File No: SP 23-01 & PA 23-01 Site Development Review and Partition for Pure Energy Group

Proposal: The applicant is proposing concurrent review of a Tentative Partition for a two lot split, one parcel is proposed to be 4.50 acres and the second parcel is proposed to be 1.25 acres, and a Site Development Review for a new 7,480-square-foot building for a solar sales and installation facility that will include an office, showroom open to the public, warehouse/ storage space and 15 parking spaces with landscaping.

PRELIMINARY CIVIL SITE PLAN
 PURE ENERGY GROUP
 TAX LOT 1200, MAP 10S-3W-21D
 MILLERSBURG, OREGON

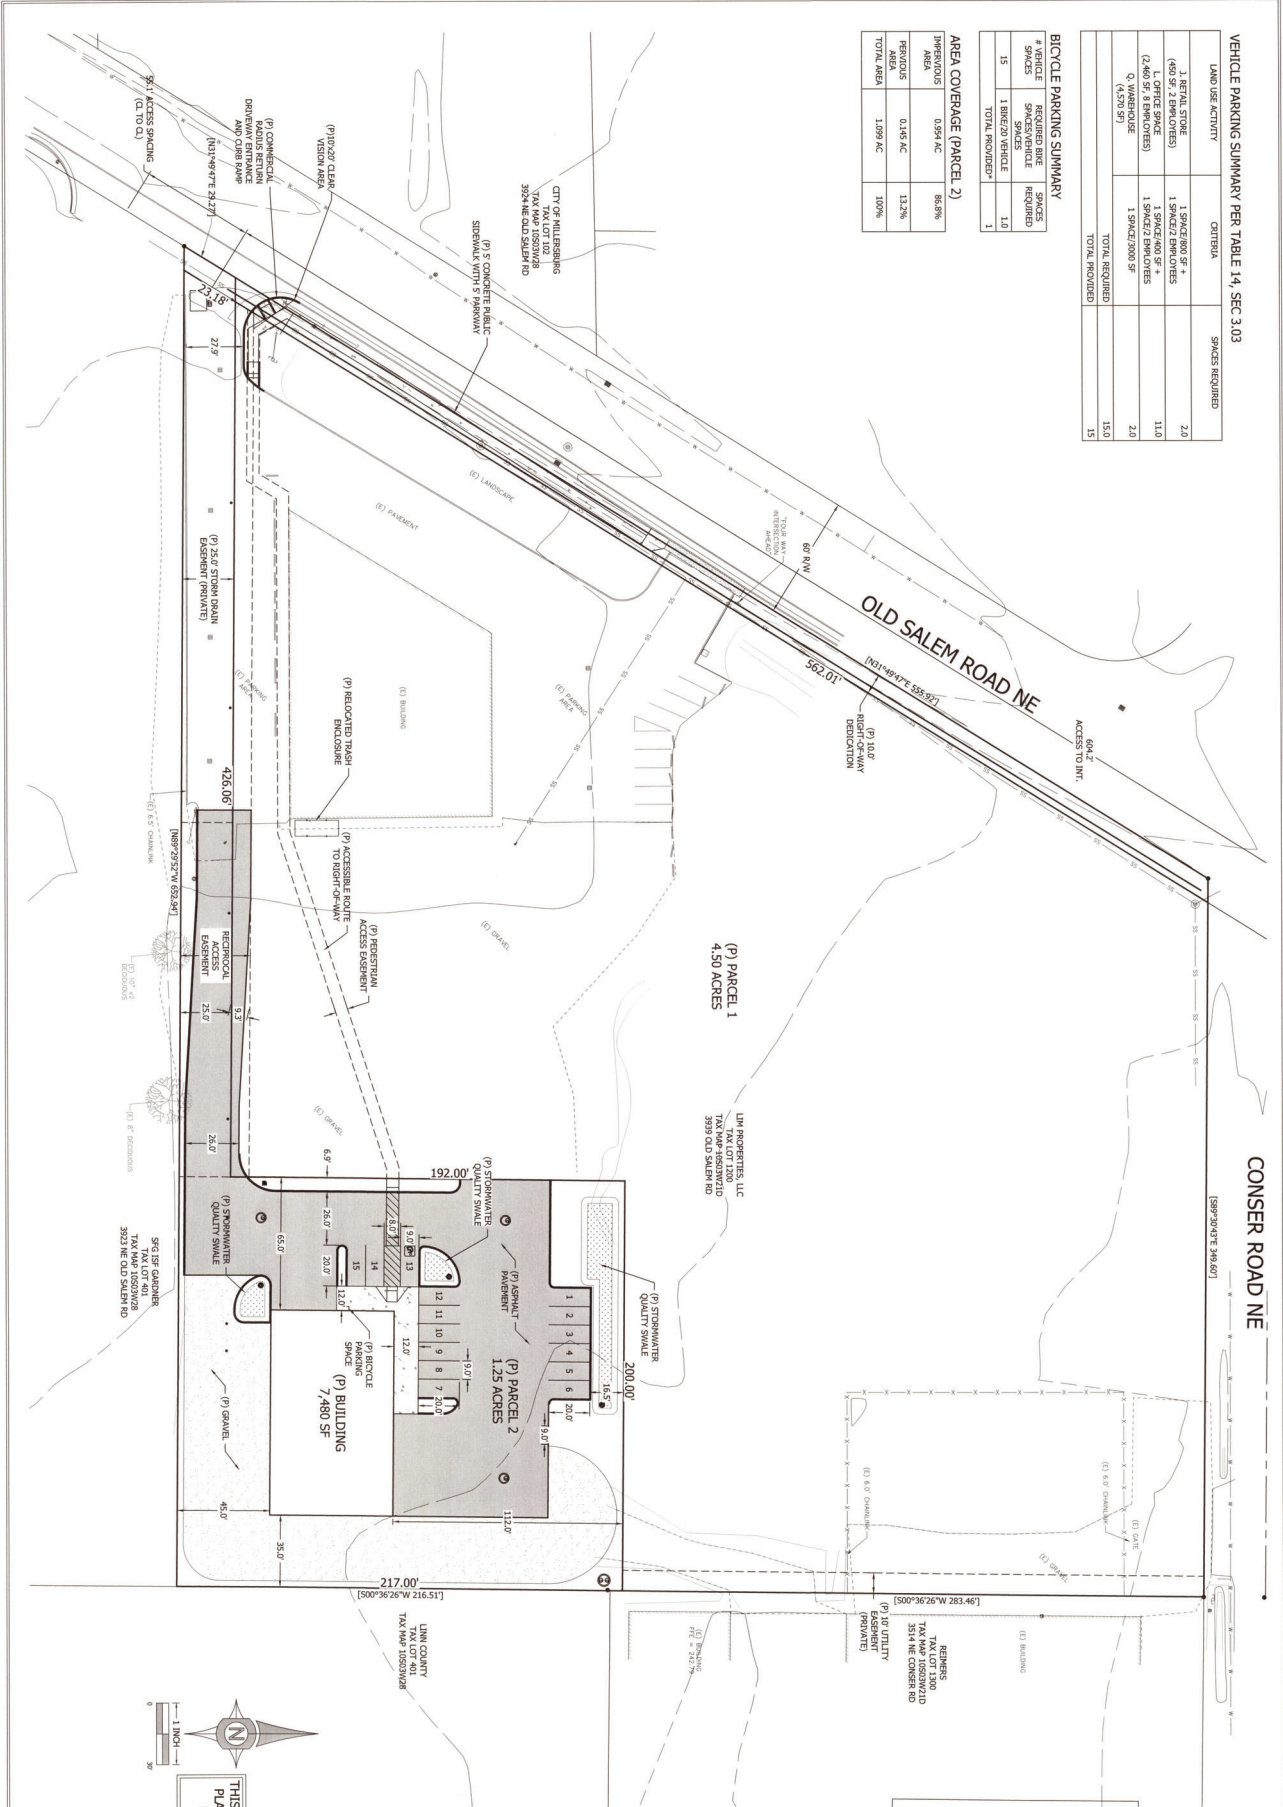
ANALYSIS: The site plan does not show any plaza area. Based on the size of the structure proposed, which is 7,480 square feet, the plaza area should be at least 70 square feet. A condition of approval has been added requiring the applicant to add a plaza to the site plan for the project. Because the location and design of the required plaza could be a discretionary interpretation, the Planning Commission may require these to be submitted prior to approving the project.

- Prior to issuance of a building permit, the applicant shall redesign the site plan to add a plaza that is at least 70 square feet and meets the requirements of 3.26.030(8), to the satisfaction of the Community Development Director.

ELEVATION EAST VIEW

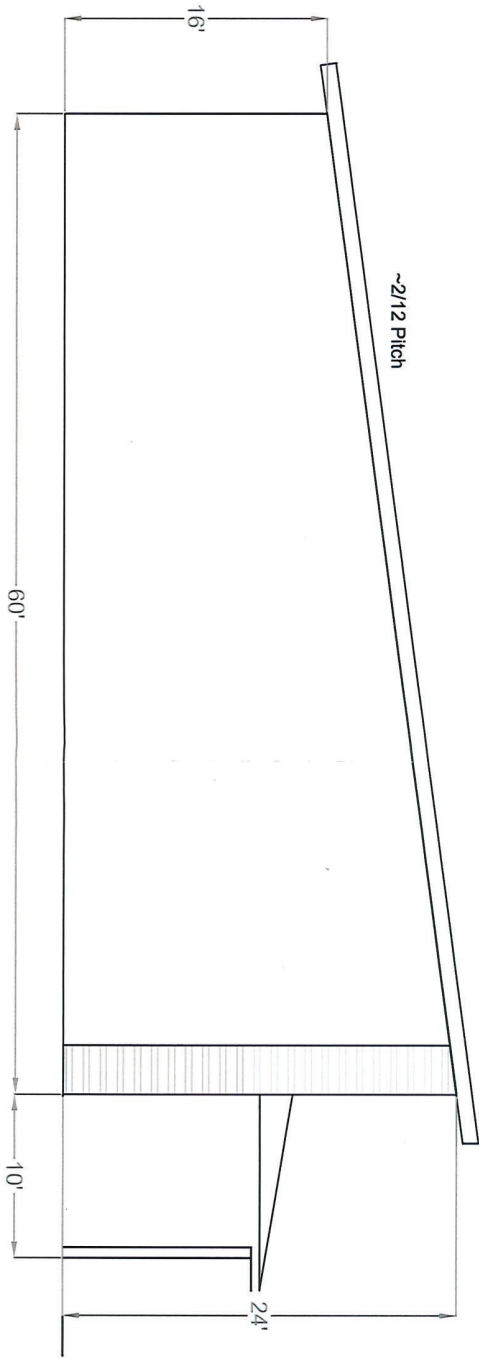
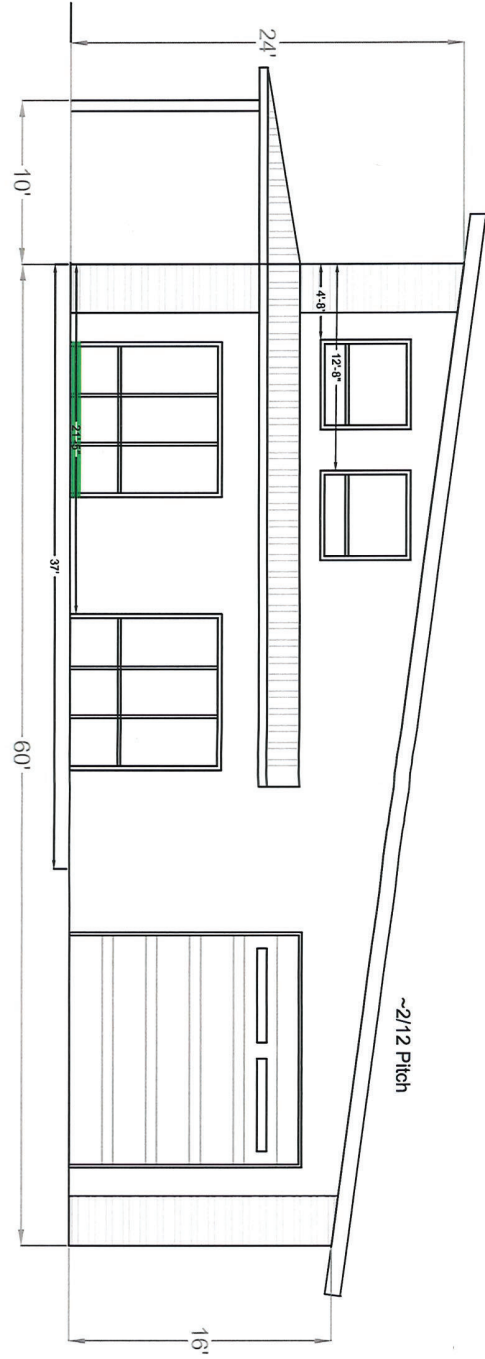
ANALYSIS: The south and west walls show no architectural features, however those walls cannot be seen from any street. The last sentence of the standard does require that all walls include features. There are also requirements, addressed further below, that a variety of finish materials are used. A condition of approval has been added to assure that a variety of building material finishes will be included on all walls of the structure and that some landscaping be added along all walls. Having that said, the standard actually calls for architectural features on 30% of all walls, even those not facing a highly visible street. However, because the south and east walls are situated such that no one will be able to see them, adding architectural features would be excessive. Staff is planning to update the Development Code so that this will no longer be part of the standard; in the meantime, staff is interpreting that a variety of building materials on all walls (even the south and east walls) will be enough to satisfy the intent of this standard. Naturally, that is up to the Planning Commission to decide.

The west and north facing walls are visible from the street and therefore apply. The elevations show compliance with the windows requirements. The applicant's narrative explains that a 2/12 roof pitch and combinations of wall finishes show compliance. Covered awnings are included as well. The Code further requires that at least 50% of the walls length include

architectural features and landscaping. As submitted, the west wall meets this requirement, the north wall does not appear to meet the requirement. It seems all architectural features cover only about 40% of the wall length. Additionally, it is not clear if the landscaping will cover 50% of the wall length because landscape plans were not provided. Conditions of approval have been added. Because this requirement may be a discretionary interpretation, the Planning Commission may require these to be submitted prior to approving the project.

- Prior to building permit issuance, the building plans for the north façade shall be revised to include architectural features along at least 50% of the wall length, to the satisfaction of the Community Development Director.
- The north and west facing wall of the structure shall include landscaping along the façade of the structure for at least 50% of the wall length (abutting the building), to the satisfaction of the Community Development Director.
